**Remote Control Malfunction or Radio Reception Problem**

E61 (5 Series Sports Wagon) produced up to 1/2008

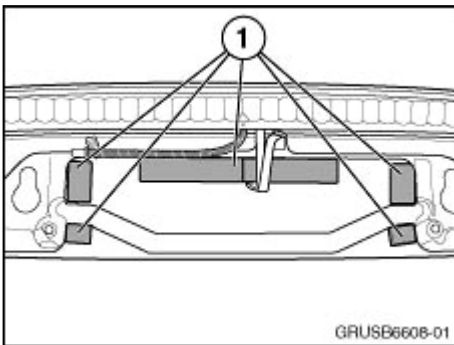
The diversity antennae located under the rear (tailgate) spoiler may have been water-damaged due to the spoiler and the antennae trim not fitting properly.

Install foam spacers at specified locations on the underside of the rear spoiler.

6. Install the 5 new foam spacers (1) to the areas identified in the illustration.
